ADDENDUM NO. 06

Date of Issuance: January 8, 2025

Project: **2024 Jersey Village High School Renovation**
 Cypress-Fairbanks Independent School District

Texas Arcadis Inc.
 Project No.: 202319

G1.04
 PHASING 1ST FLOOR PLAN

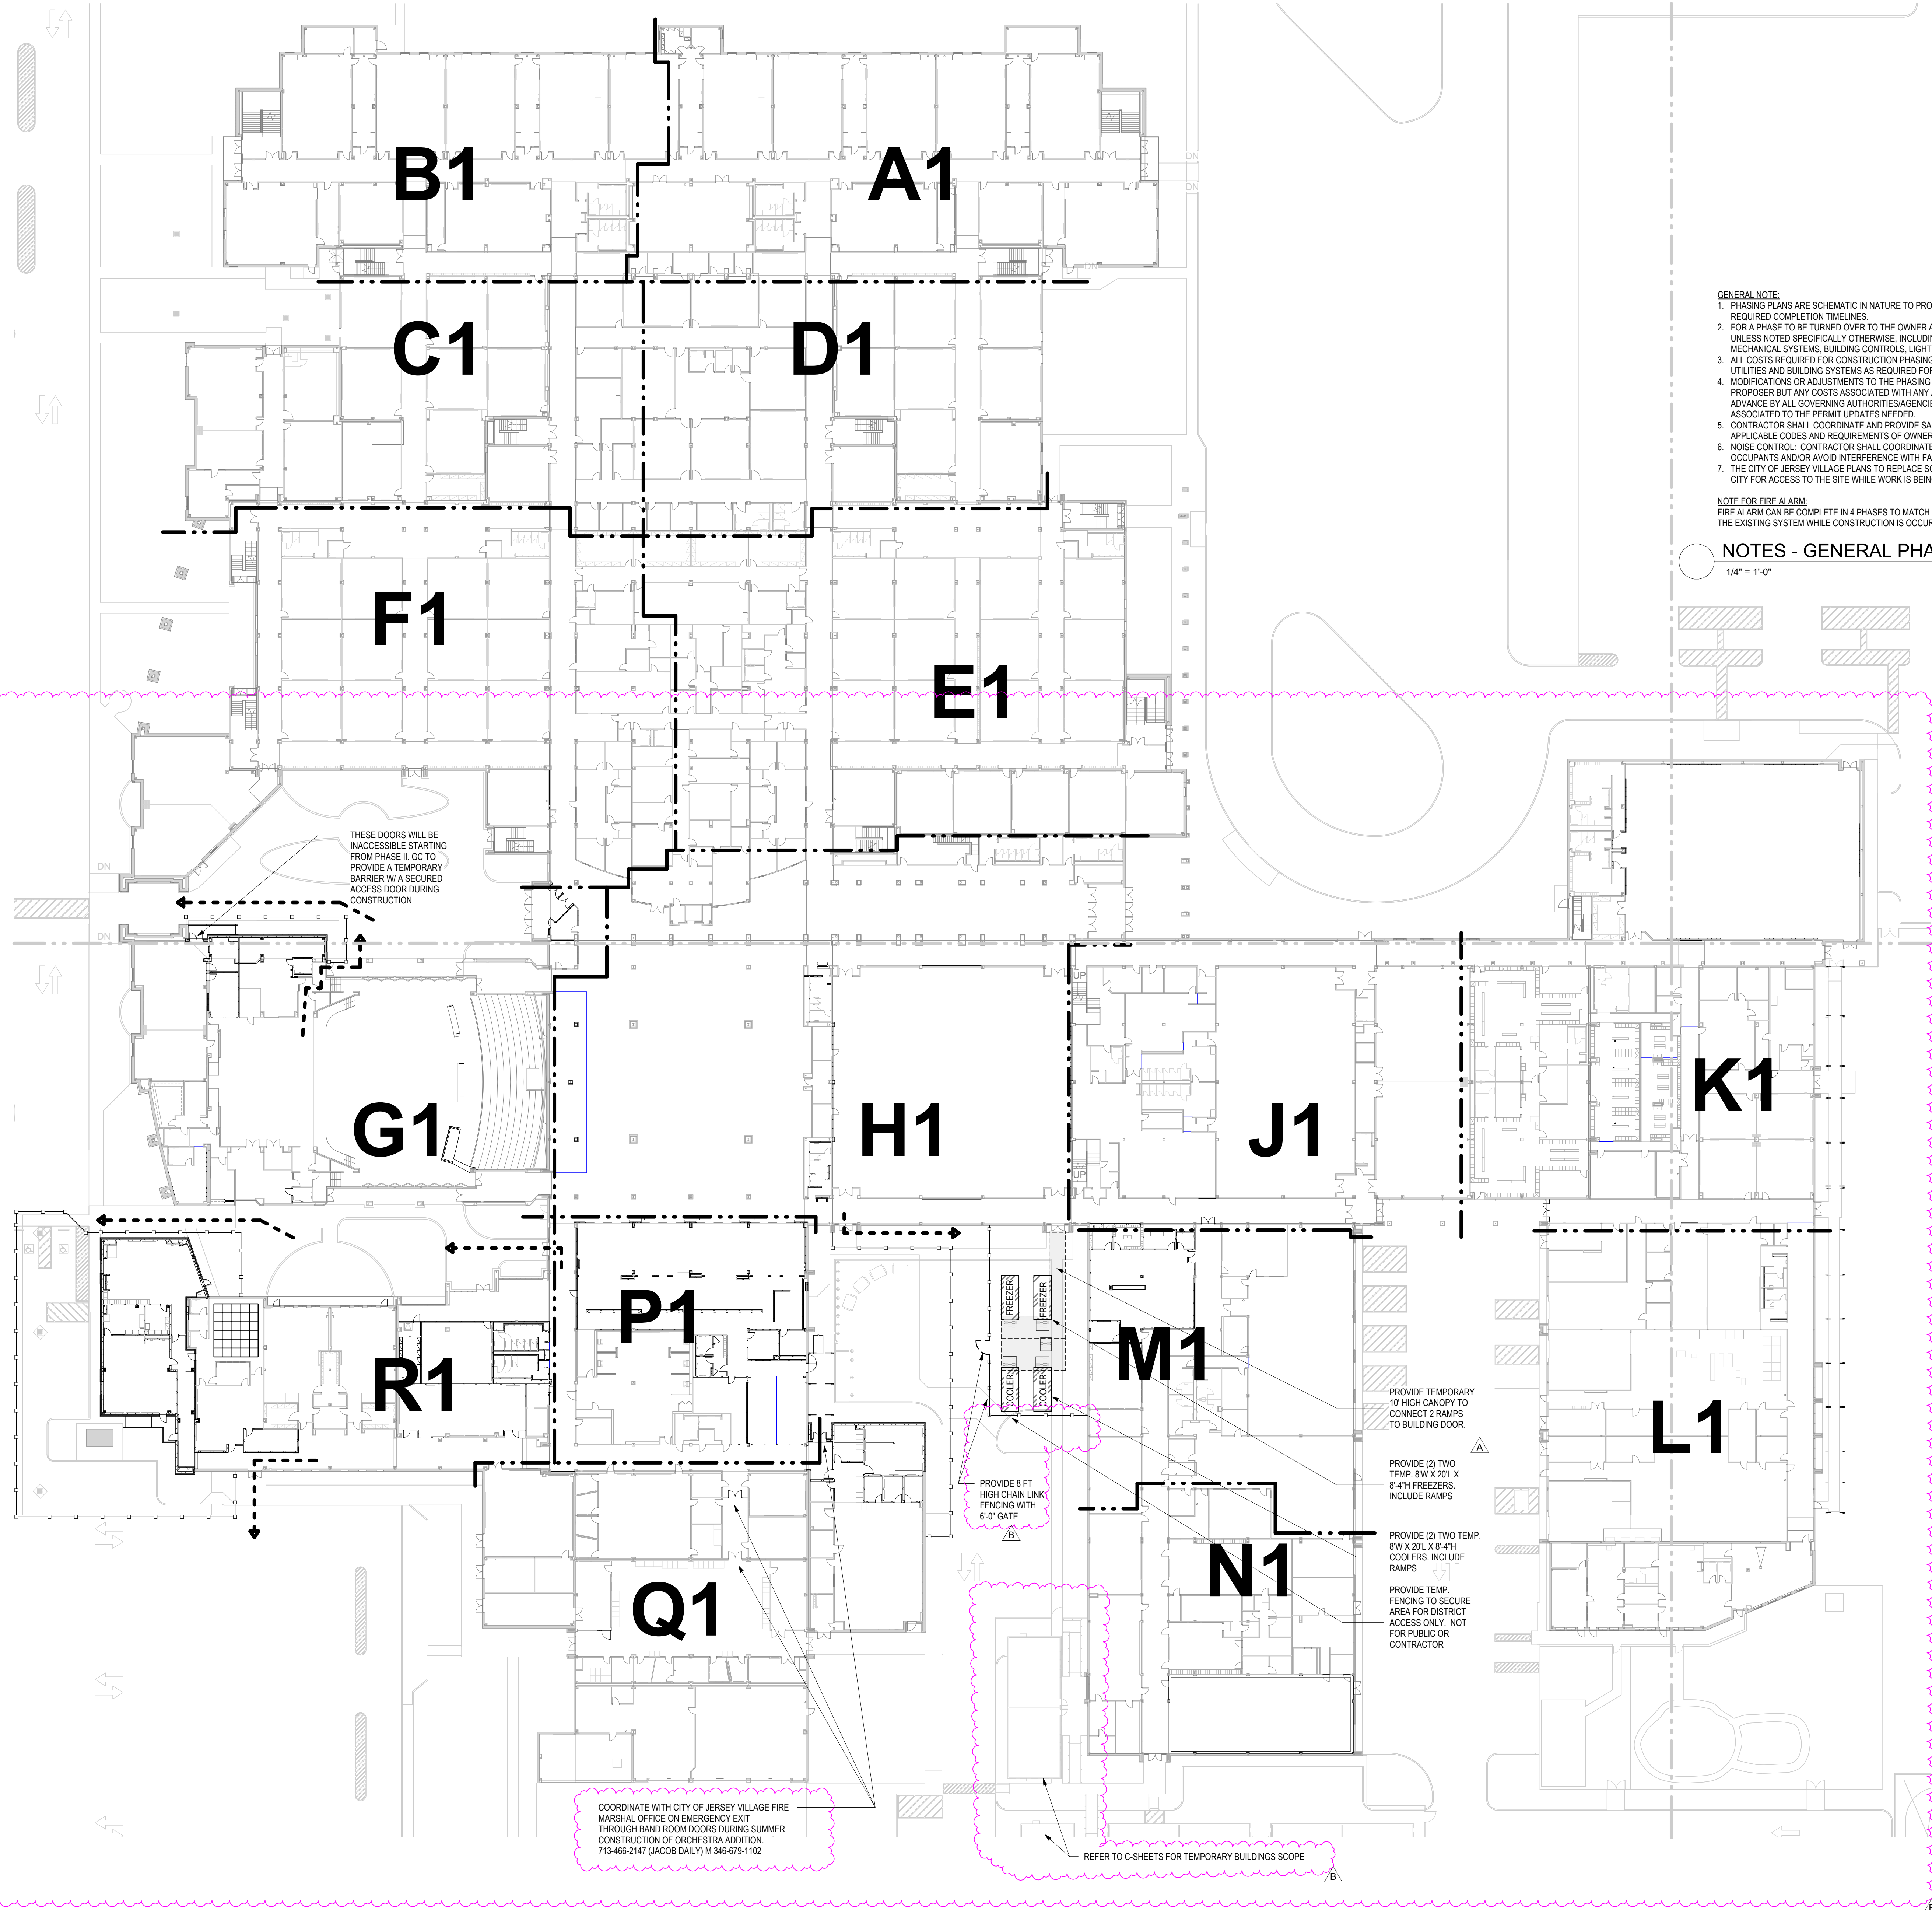
18. Sheet G1.04 – Phasing 1st Floor Plan
 - a. Revise per reissued sheet for phasing construction schedule.
 - b. Revise phasing egress notes per reissued sheet.
 - c. Add temporary cooler/freezer fencing and temporary buildings notes per reissued sheet.
